ADDENDUM 01

BID FOR : *Campus Gateways, McNeese State University, Lake Charles, Louisiana 70607*

Addendum No. 01

PROJECT:
Campus Gateways
McNeese State University
Lake Charles, Louisiana
19-627-21-01, F.19002583
01-107-05B-13, F.01004545 (Supplement)

E103
CAMPUS GATEWAY 04 -
ELECTRICAL PLANS

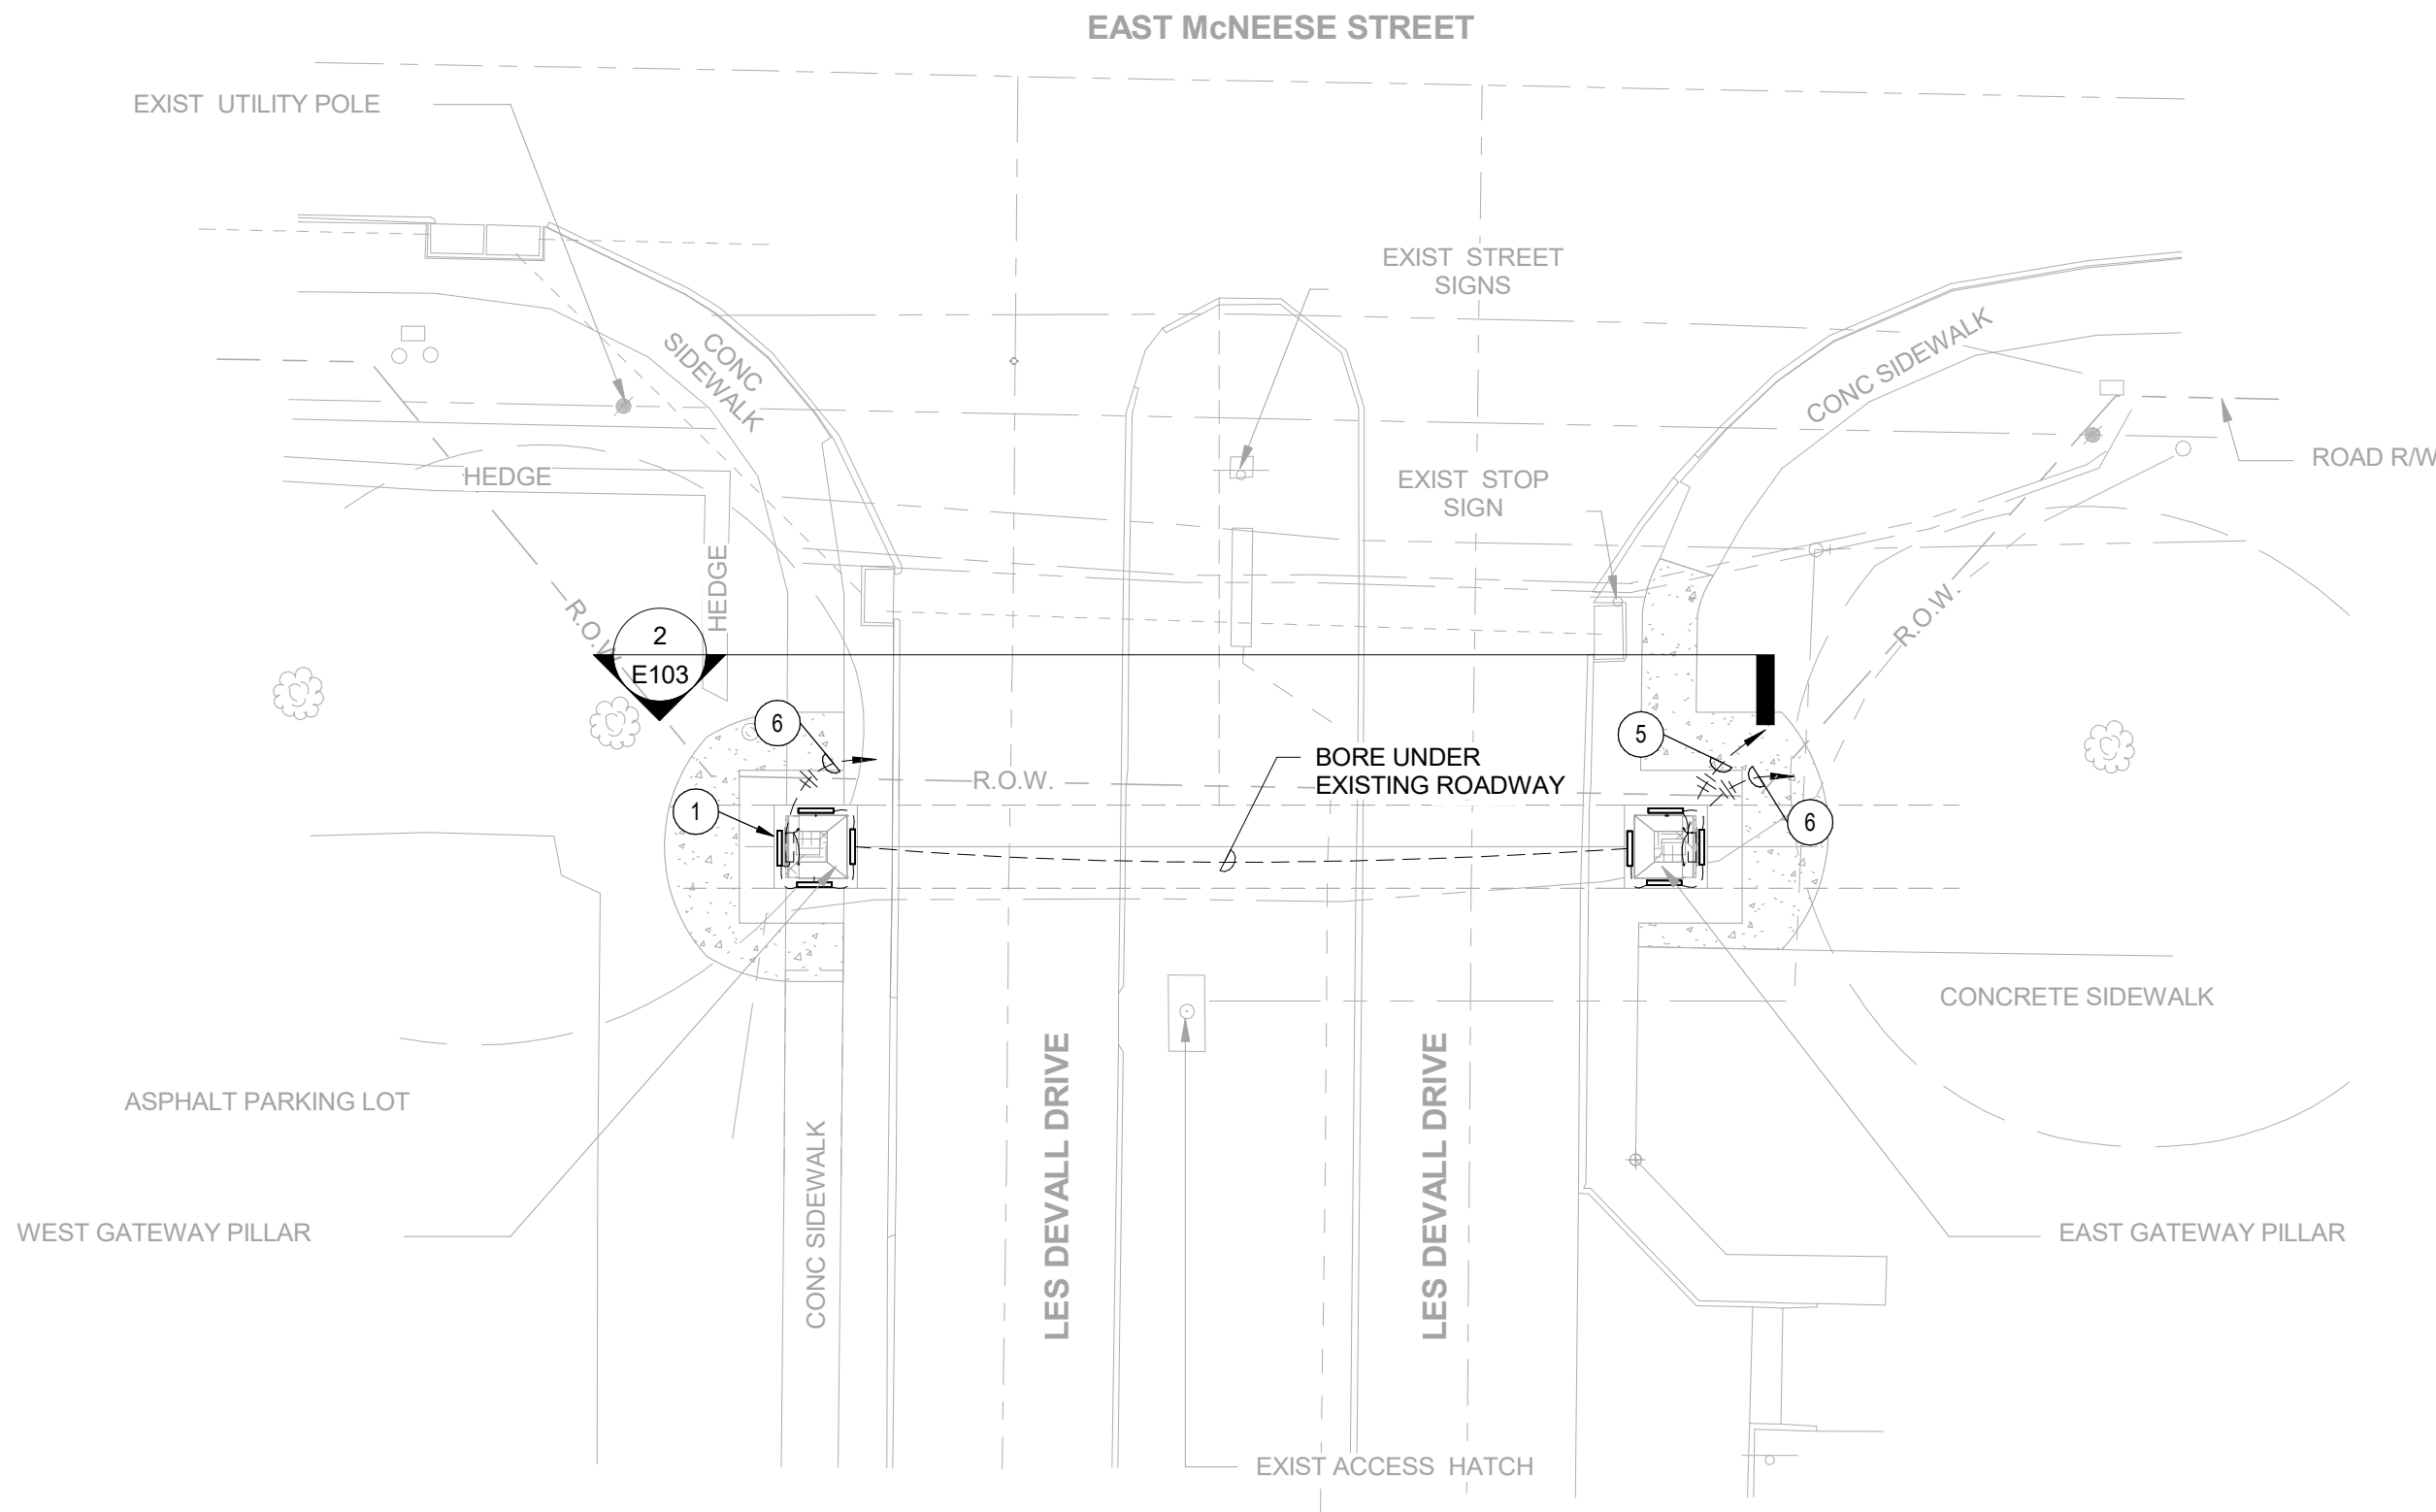
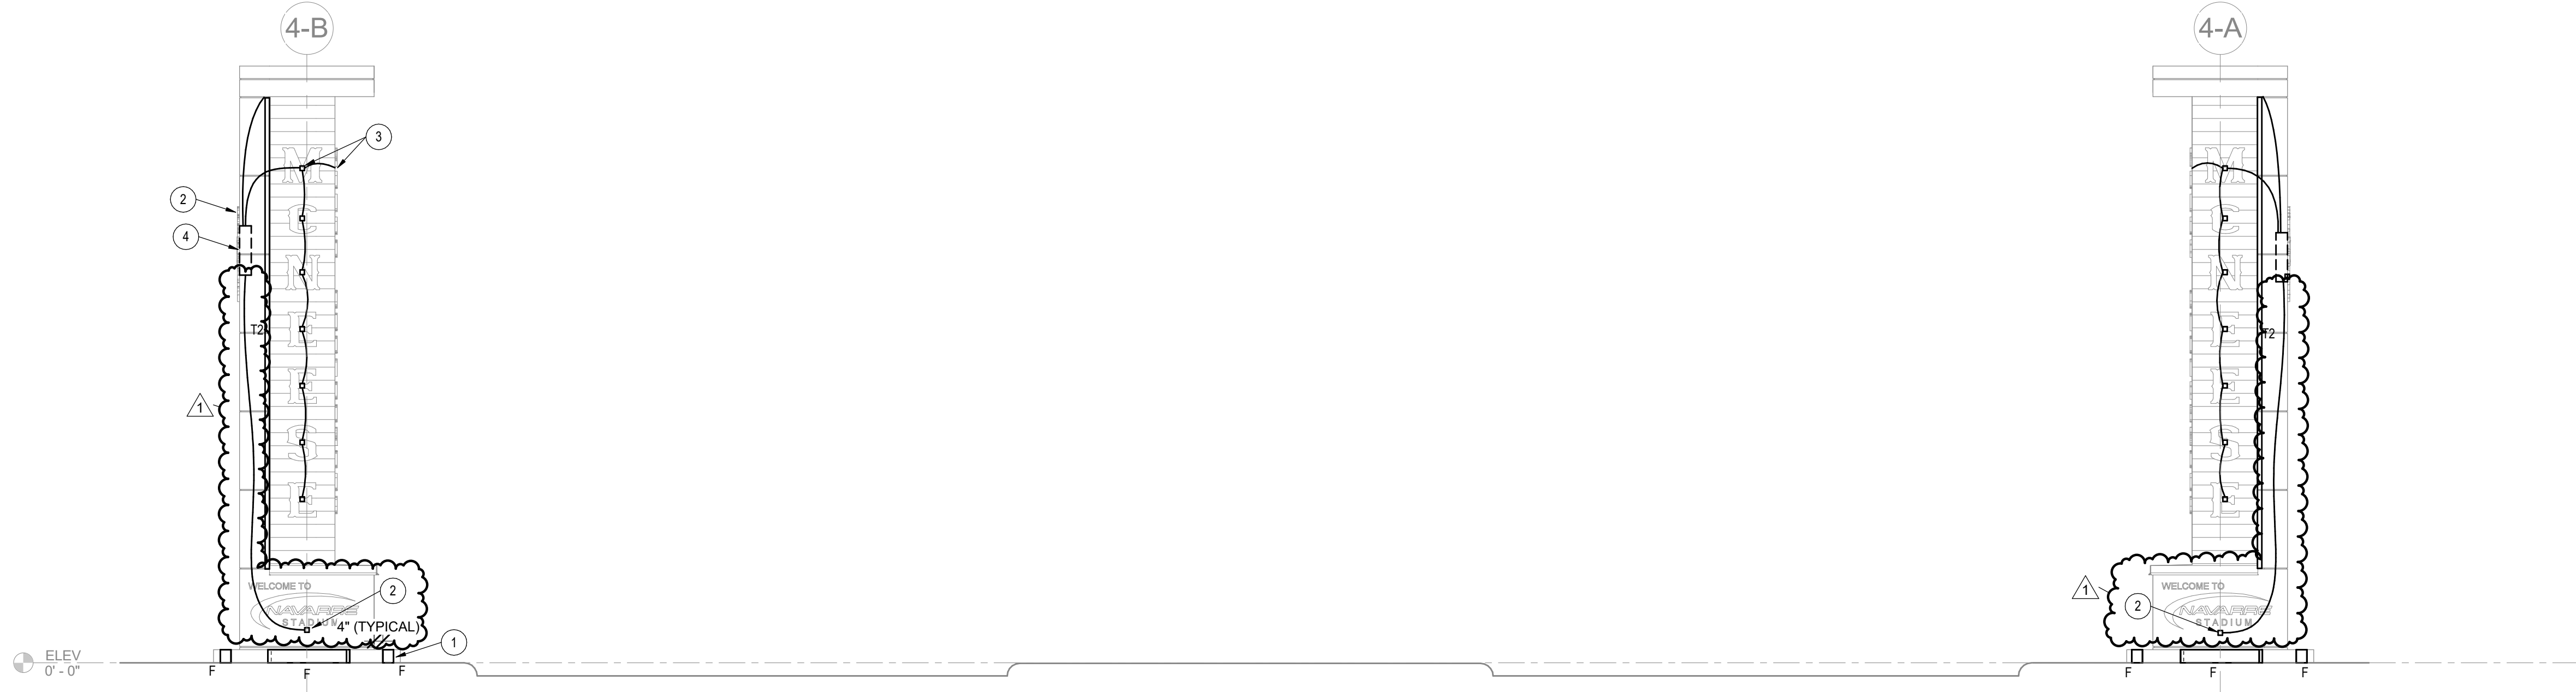
- d. Sheet E102 – Campus Gateways 03 & 05 – Electrical Plans revision 1 Seq. 1 – ADD NO. 1 dated 10/16/26.
- e. Sheet E103 – Campus Gateway 04 – Electrical Plans revision 1 Seq 1 – ADD NO. 1 dated 10/16/26.
